**From:** [REDACTED]  
**Sent:** 18/07/2023 7:58:48 PM  
**To:** Council Northernbeaches Mailbox; Maxwell Duncan  
**Cc:** Steven Findlay; [REDACTED]; 'Alba Severino'  
**Subject:** TRIMMED: DA2023/0803 - 287 Mona Vale Road, Terrey Hills - Letter of Objection - Alterations and Additions to the existing Hills flower Market Site  
**Attachments:** Objection to DA2023-0803 -287 Mona Vale Road - 18 July 2023.pdf;

**RE: Letter of Objection – DA 2023/0803**

**287 Mona Vale Road, Terrey Hills (Lot 1 DP845094)**

## Proposed Ground Floor Plan

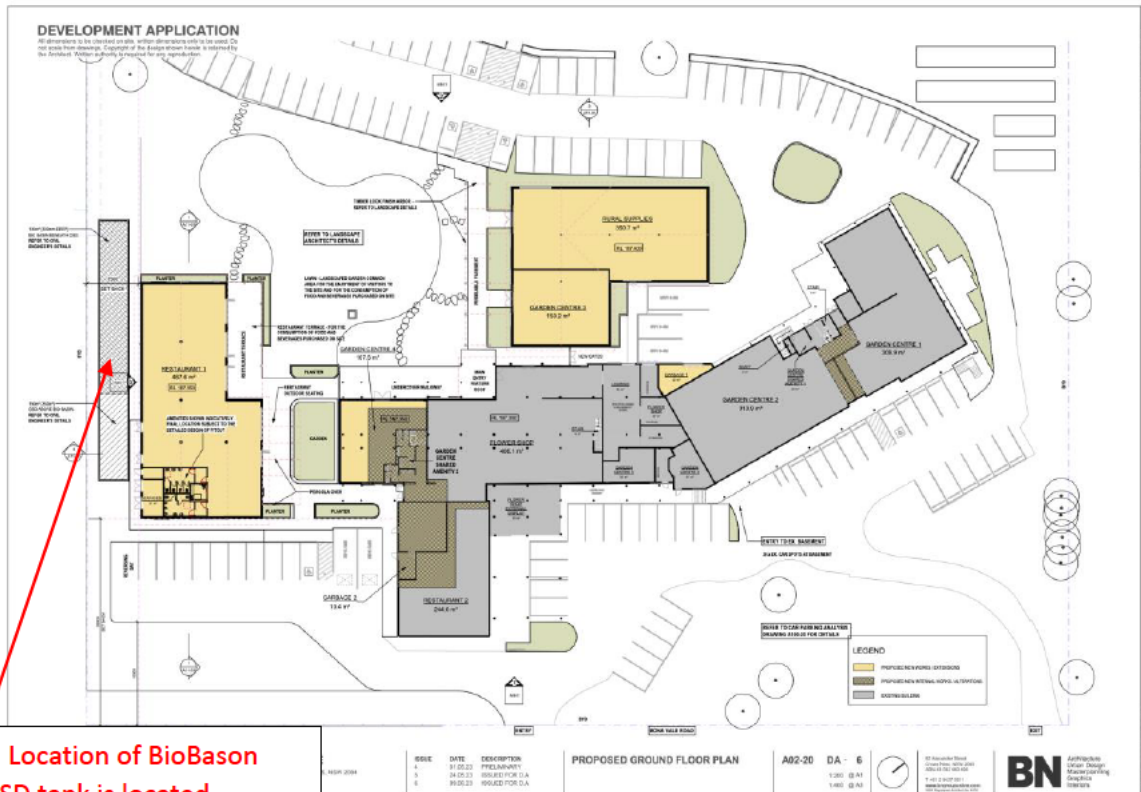
**Note:** Location of BioBasin and OSD tank is located immediately adjacent to our clients common boundary

**COMMENT:** The drawings A02 - 01 (Overall Site Plan) and A02-20 (Proposed ground floor plan) clearly demonstrate the scale of the development that is proposed to take place on this site. It represents a significant expansion over and above the building footprints that currently prevail. In particular, there is a new restaurant of 469sqm with areas shown on the architectural drawings as restaurant outdoor seating with no numbers to show the total number of people that could be accommodated within the area defined for outside dining both on the restaurant terrace and the area between the proposed restaurant and an area shown as 'gardens' on drawing A02-020.

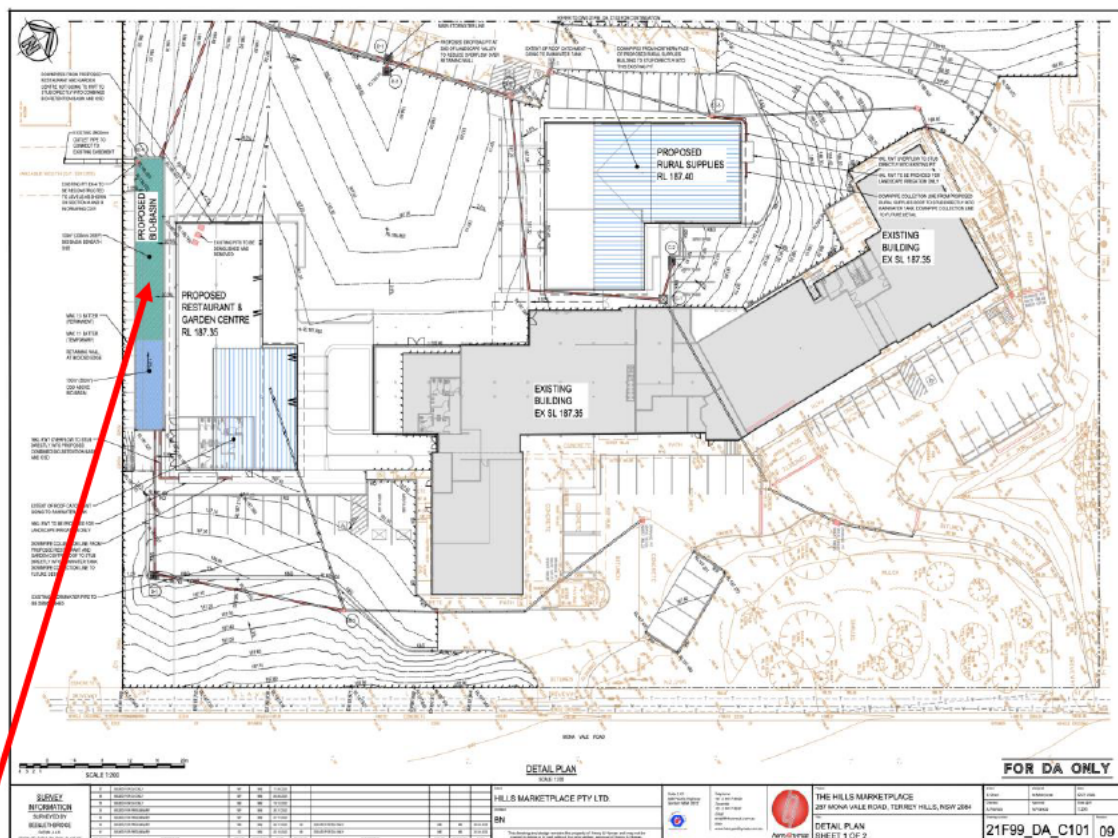
**Comment:** the above photograph shows the drainage system currently in place on the Miramare Gardens property, where the pipe from the adjoining property discharges.

**Comment:** drainage pipe referred to in the Civil Engineering drawings is shown above. This pipe does not extend through our client's property.

**Comment:** drainage outlet for water overflow onto Miramare property.

**Comment:** any excess flow of water would lead to damage to the main Miramare building.

**Proposed detention tank and biofilter**

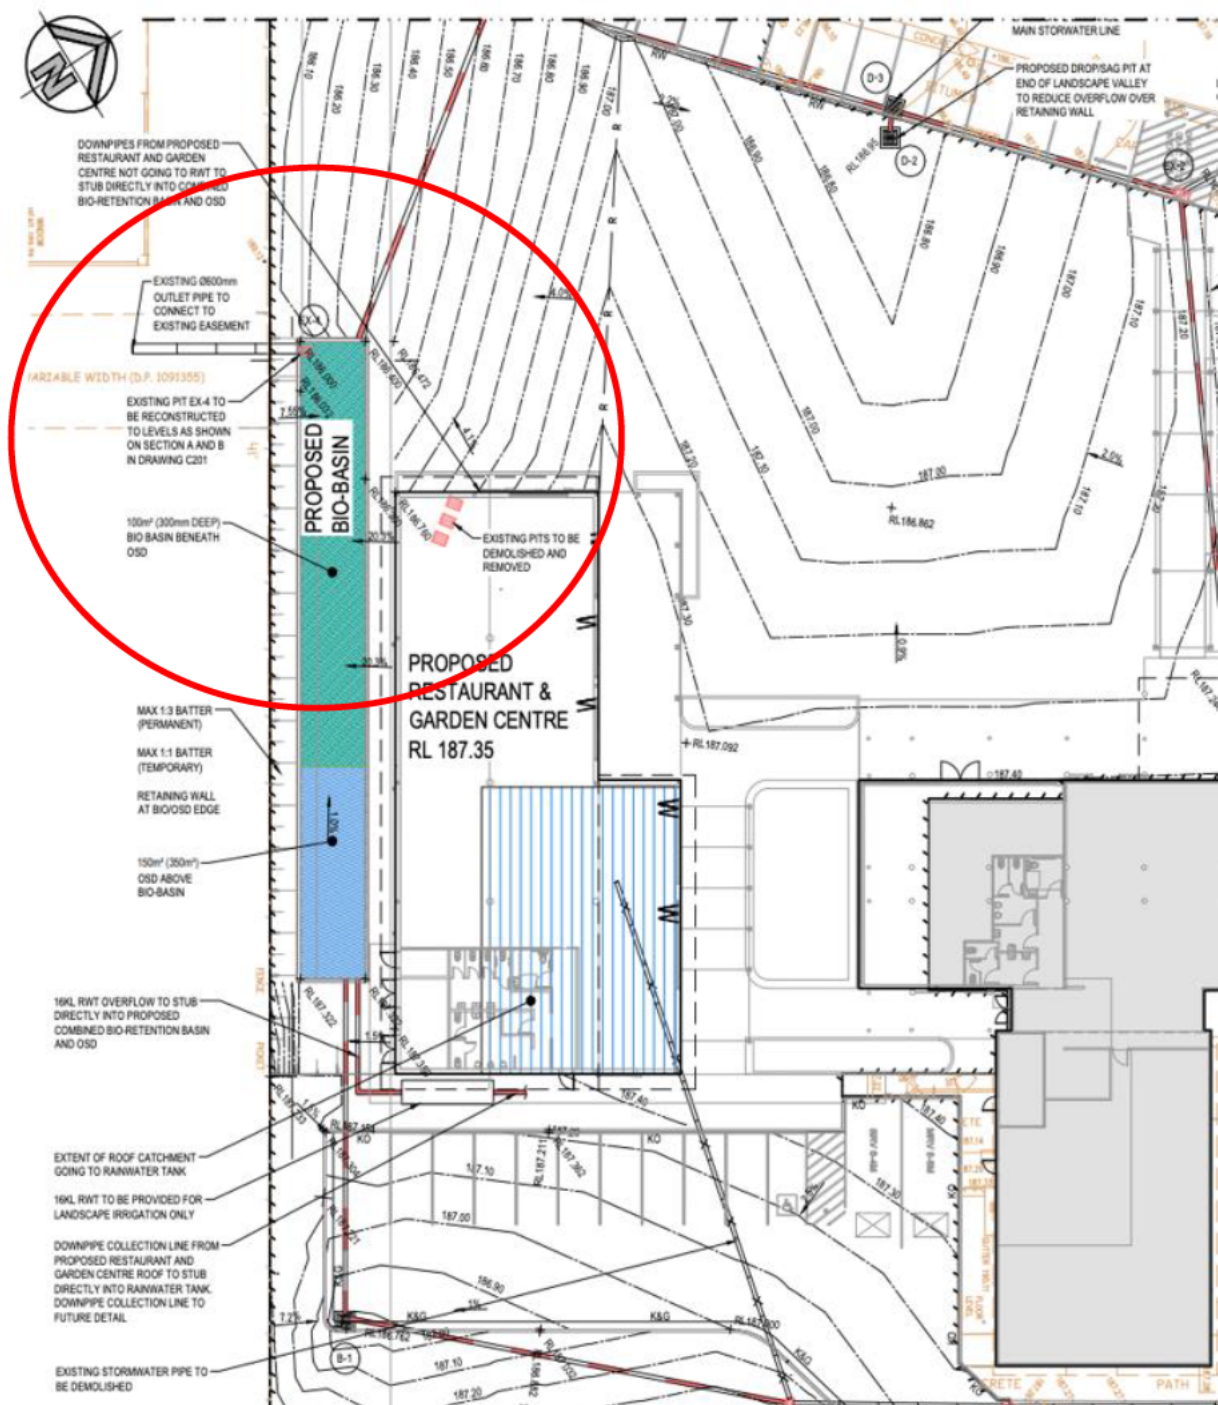
**Comment:** the above civil engineering drawing states, “existing 600mm outlet pipe to connect to existing easement”. We cannot locate any hydraulic analysis regarding the quantity of stormwater that has been catered for by way of the significant enlargement of the new development and how the existing drainage system would cope with the volume of stormwater from the new buildings and other infrastructure that will flow into the detention tank.

Our clients are genuinely concerned that the proposed Bio-Basin and OSD tank will be built almost on their boundary. They are also alarmed that there will be extensive excavation to accommodate this drainage infrastructure, which could adversely affect the stability of their existing fence and wall which form an integral part of their drainage system. Infrastructure of this length and depth should be located a minimum of 5m from any common boundary. When Miramare was approved, Council required a 5m setback of the building and any structure. To allow a setback of 1m for the proposed infrastructure as shown on the civil engineering drawings is absurd. There is ample room on this site to move the Bio-Basin and OSD facility to the north to ensure a minimum 5m setback. Once again, the 1m setback shows little or no regard for our clients and the detrimental impact certain components of this development will have on Miramare Gardens.

1. Redirect all stormwater by way of a pipe system to Council's stormwater drainage system in Myoora Road, consistent with other new development requirements.
2. Construct a piped drainage system within the easement of our client's property to enable the stormwater to discharge into the creek system which is located on the Catholic Church property. All works would be carried out in accordance with an agreement between both landowners and the works would be undertaken at a cost to the applicants, including any restoration of the existing drainage area.
